### STAFF RECOMMENDATION 1406 Fifth Avenue North November 18, 2015

**Application:** Partial demolition; New construction—addition

**Description of Project:** Application is to construct a two-story addition that is eight feet, four inches (8'4") taller than the one-story historic house.

SITE & DEMOLITION PLAN

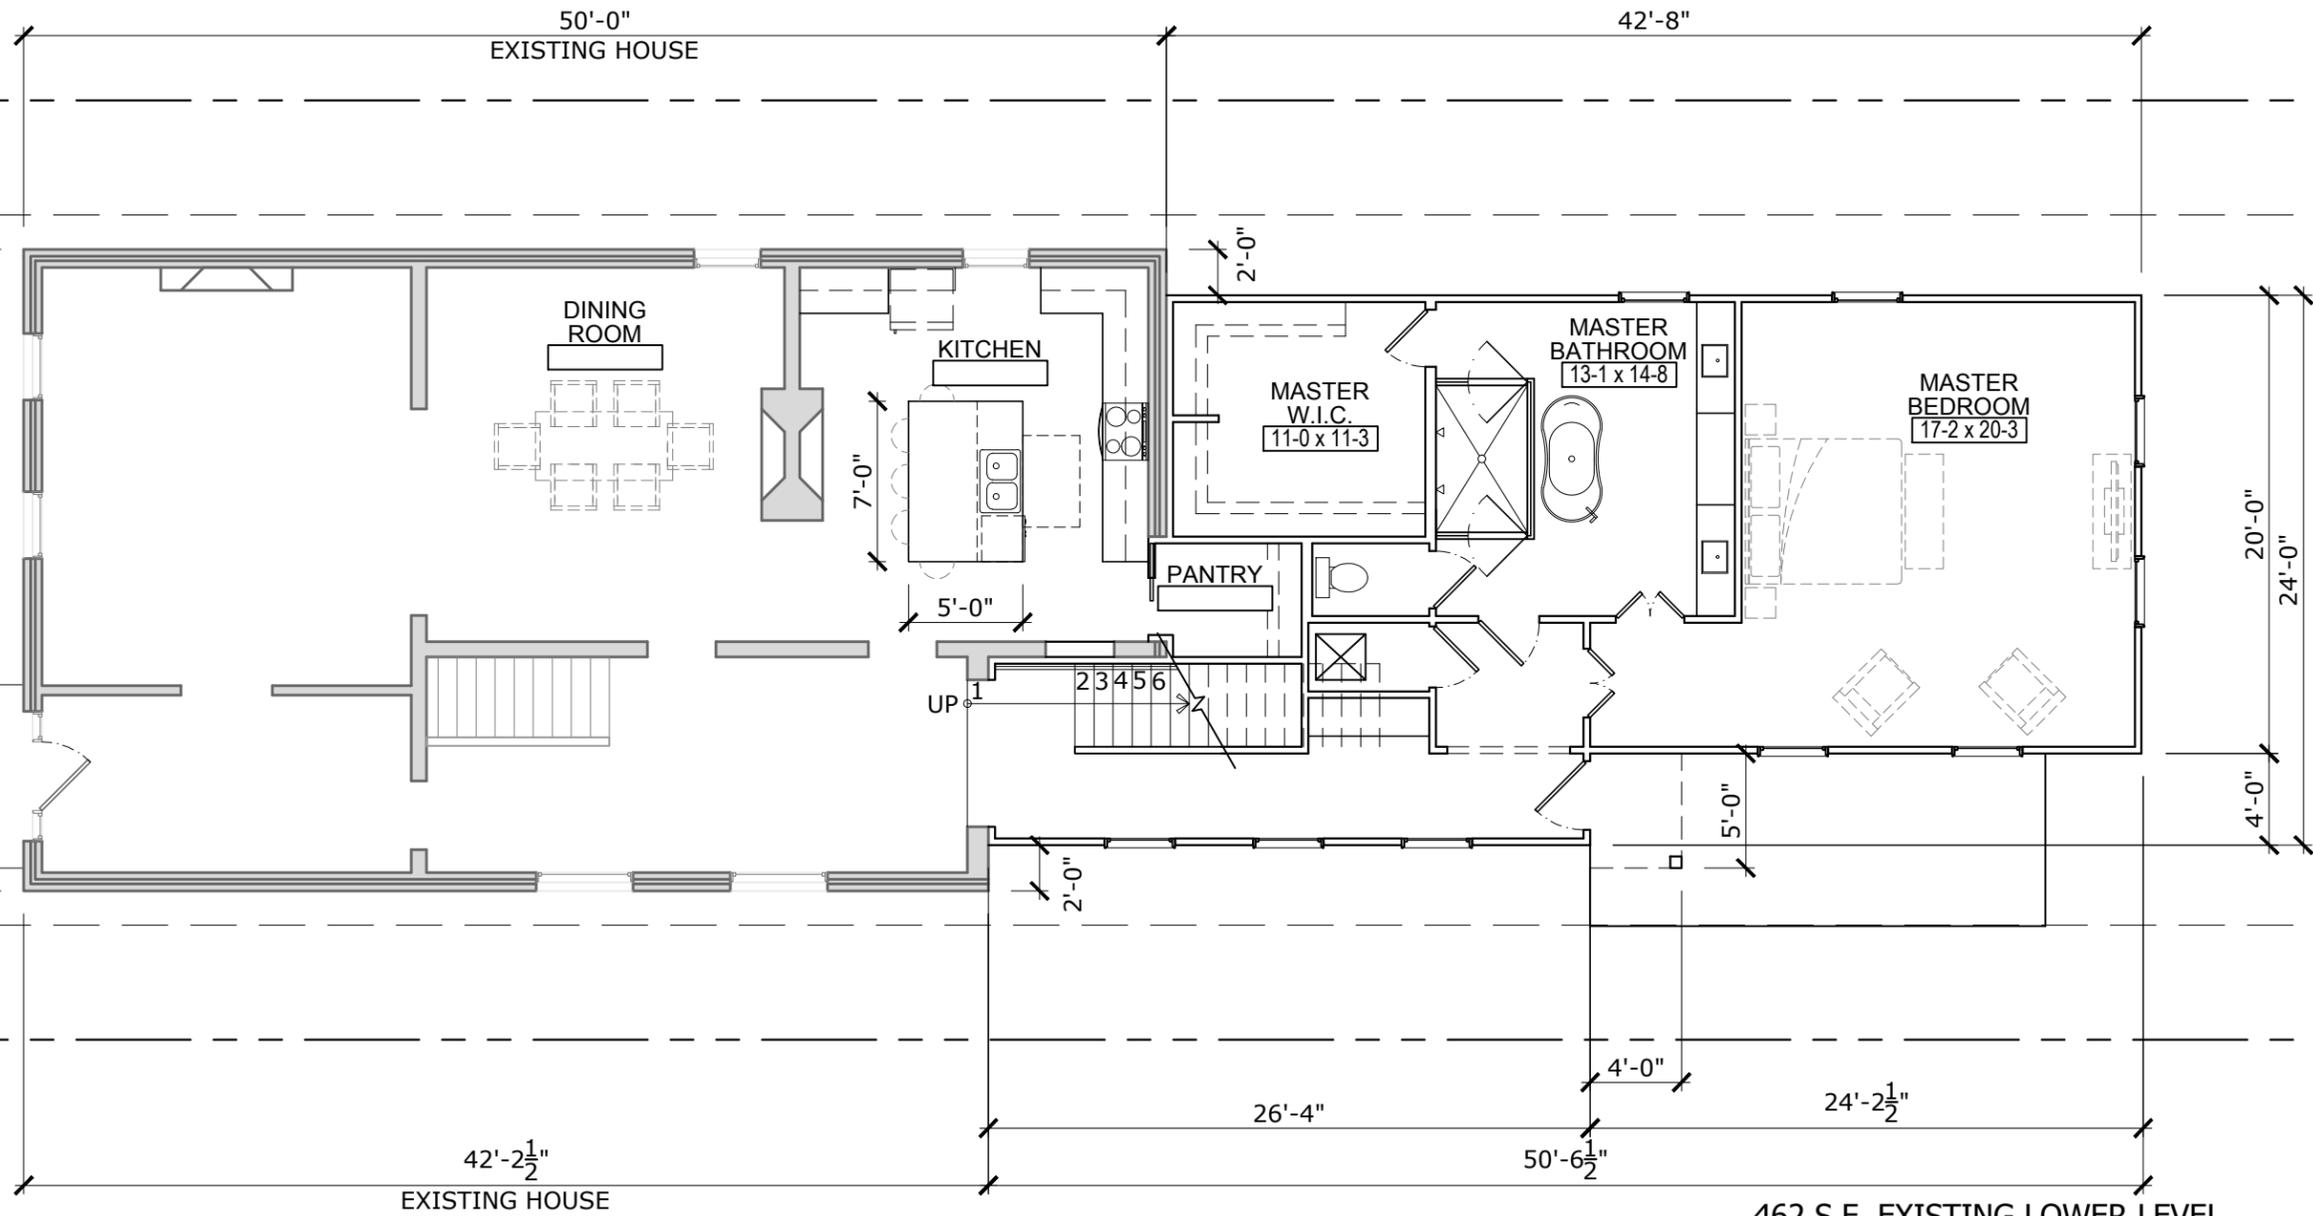
Partial Demolition. The applicant proposes to demolish an existing addition at the rear of the house. This part of the structure does appear on the 1914 Sanborn Map, and is shown as a distinct element from the rest of the house (Figure 2). The existing addition is clad in siding and has a separate roof from the brick house (Figures 3 - 5). It is located over forty-feet (40’) from the front of the house on the right side and about fifty feet (50’) from the front on the left side. It is at most minimally visible from the street. Staff finds that the existing addition does not contribute to the historic character of the historic

house at 1406 Fifth Avenue North and to the Germantown Historic Zoning Overlay as a whole. Staff finds that its demolition meets Section 7.2.2. for appropriate demolition and does not meet Section 7.2.1. for inappropriate demolition.

WEST ELEVATION

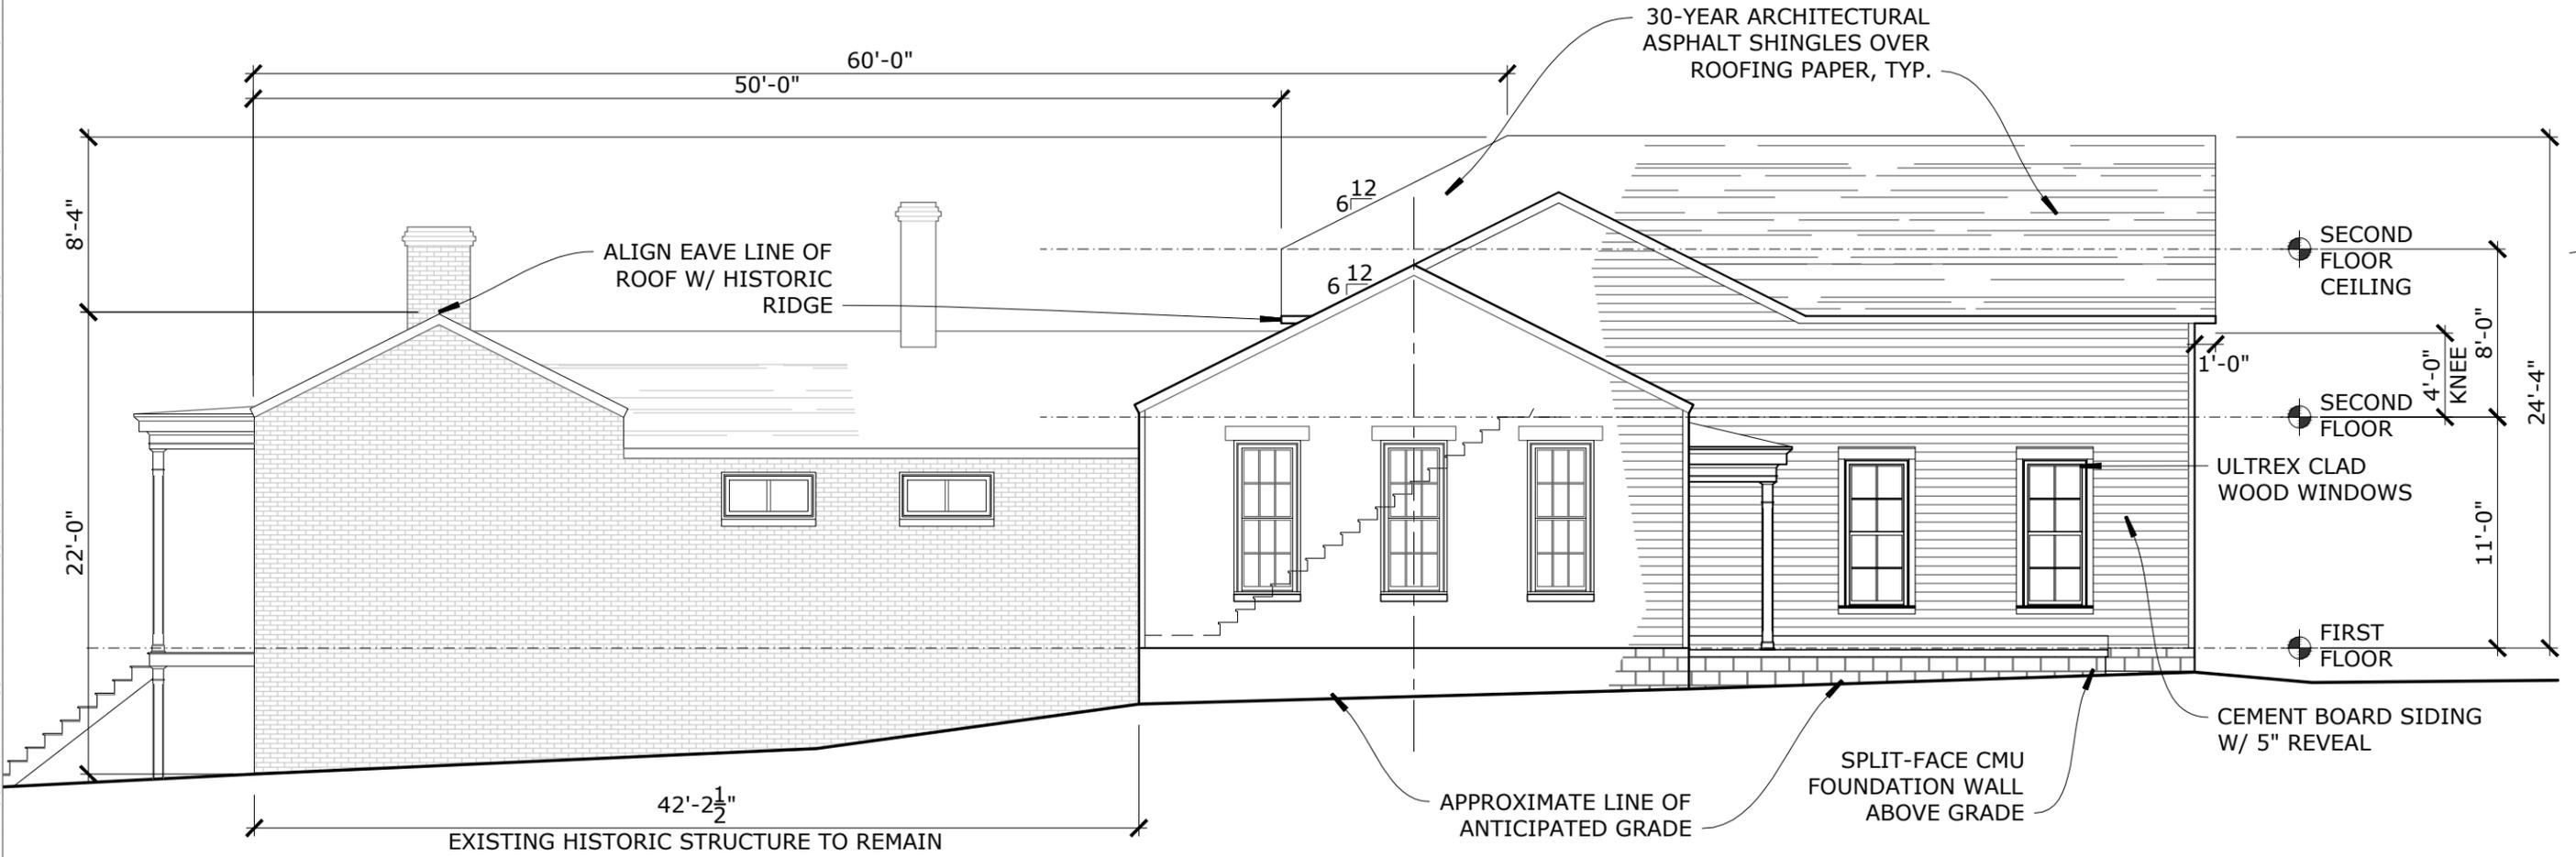
The proposed two story addition will be a total of eight feet, four inches (8'4") taller than the historic house, and will be about nine feet, two inches (9'2") taller than the cross-gabled portion of the house. The addition will be inset a minimum of two feet (2') at all points, and it will have a depth of about fifty-feet, six inches (50'6") on the right side and forty-two feet, eight inches (42'8") on the left side. By comparison, the historic house, once the existing additions are demolished, is forty-two feet (42') deep on the right side and fifty feet (50') deep on the left side.

The addition is appropriately inset at least two feet (2') on each side, and the front-facing portion of the roof is clipped. Staff does not find that the proposed height and scale of the addition are appropriate for several reasons. The applicant proposes that the addition be eight feet and four inches (8' 4") taller than the existing one-story house. Despite the fact that the steep slope of the site, and its rocky terrain create an unusually difficult site to build upon, a two-story addition to a truly one-story home is generally inappropriate as it creates a massing that overwhelms the home. In the past, the Commission has allowed for as much as four (4') above the ridge height if the addition sits back from the front wall by at least forty feet (40'). Because this addition sits back five feet (5') more than forty feet (40'), staff recommends that the addition be no more than five feet (5') taller than the existing building. With the clipped gable design the applicant proposes, this will assure that only roof is seen above the house, masking the additional massing.

Roof. This historic house has a side gabled roof with a pitch of approximately 5/12. The part of the addition that is over eight feet (8') taller than the historic house has a clipped gable roof facing Fifth Avenue North with a 10/12 pitch. The other portions of the addition have side gables with a 6/12 pitch. Staff finds that the clipped gable will help minimize the visibility of the added height, and that the side gables are appropriate for the historic structure. With the condition that the addition be decreased to no more than five (5') above the existing roof line, Staff finds that the proposed roof forms meet Sections 2.7, 4.2.2., 4.2.5. of the design guidelines.

With the condition that the addition be decreased to no more than five (5') above the existing roof line, the project meets Sections 2.2.3., 2.2.4., 4.2.2., and 4.2.5. of the design guidelines for height and scale.

1. The height of the addition be lowered so that it does not exceed five feet (5') above the existing roofline;

REVISED SOUTH ELEVATION

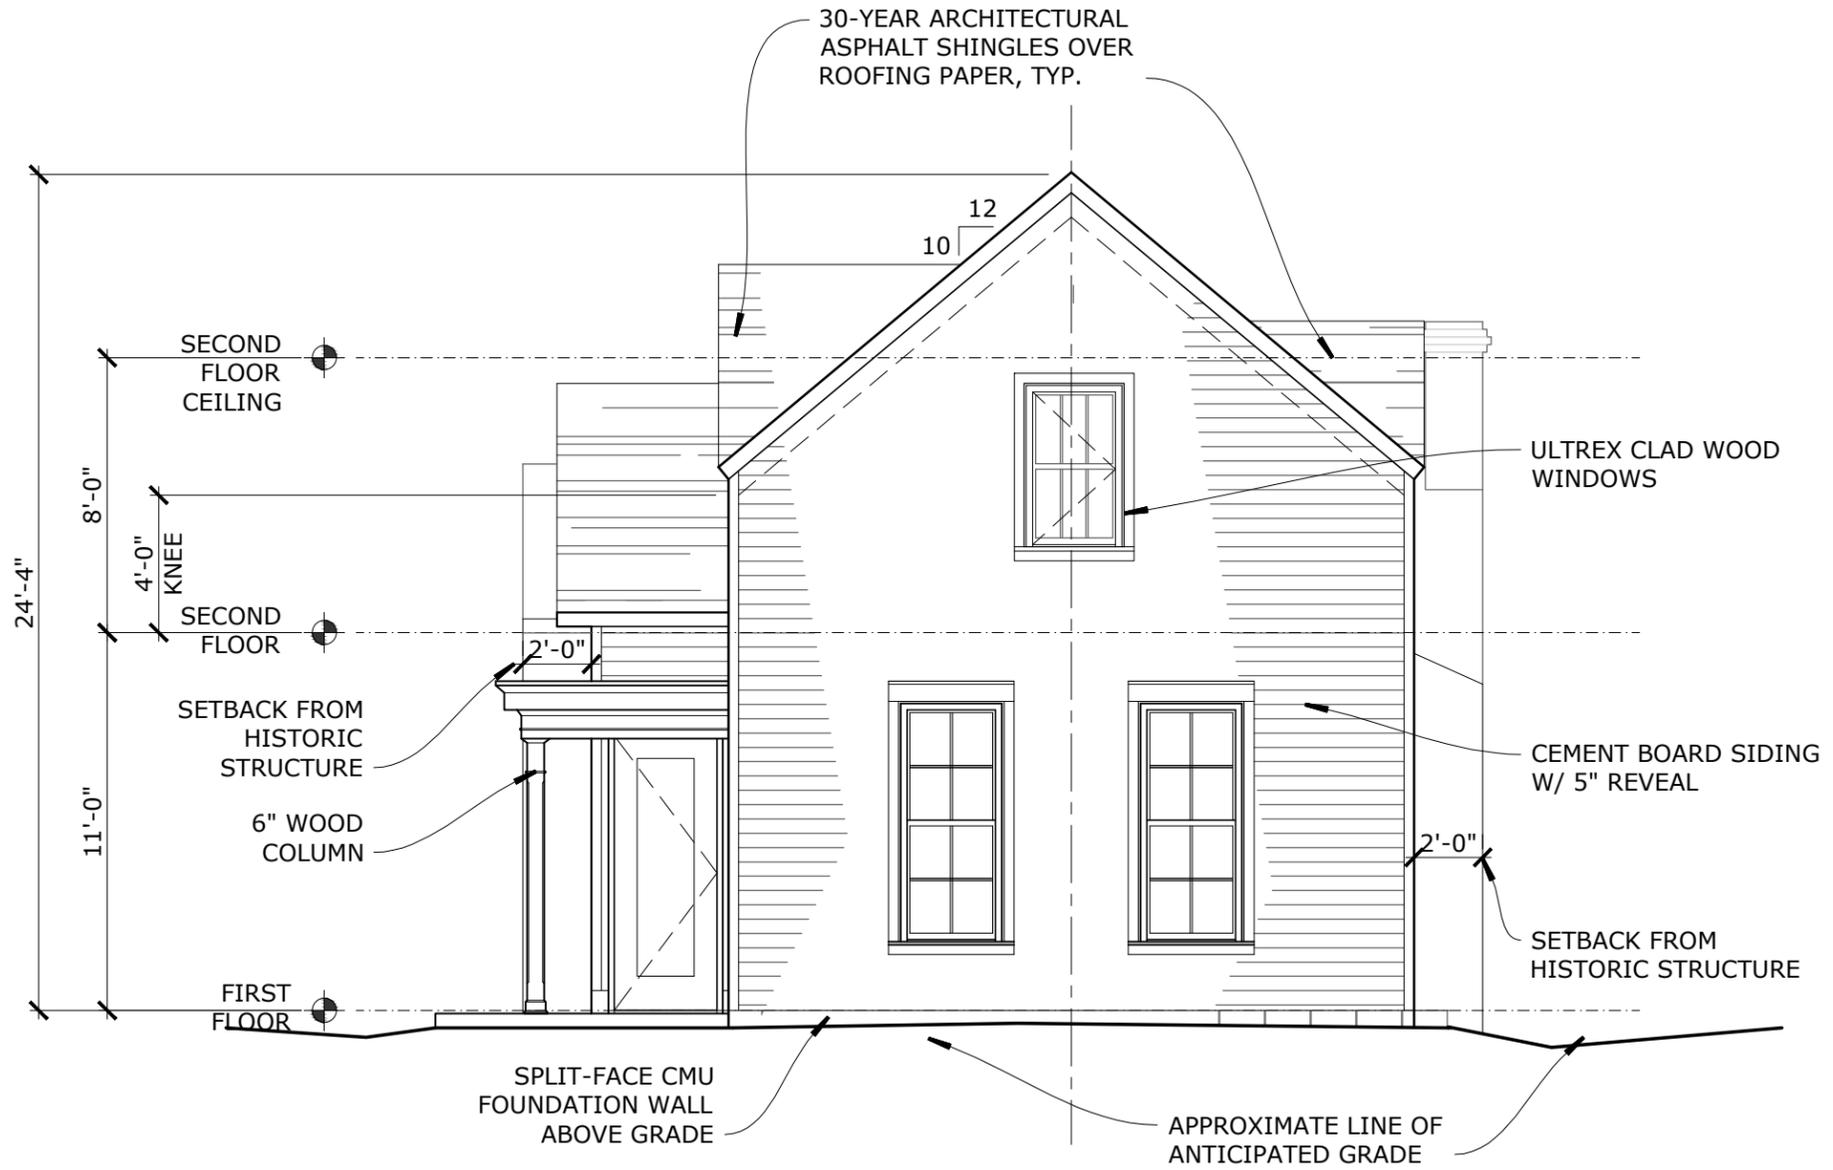
Windows and Doors. The drawings do not indicate any changes to the existing window or door pattern. The addition's windows are generally twice as tall as they are wide, thereby meeting the historic proportion of window openings. There is an expanse of nineteen feet (19') without a window or door opening on the south/left elevation, which staff finds to be appropriate because this portion of the addition is over fifty feet (50') from the front of the house and is inset two feet (2'), meaning that it will not be highly visible from the street. Staff finds that the proposed windows and doors meet Sections 2.5, 2.6, and 4.0. of the design guidelines.
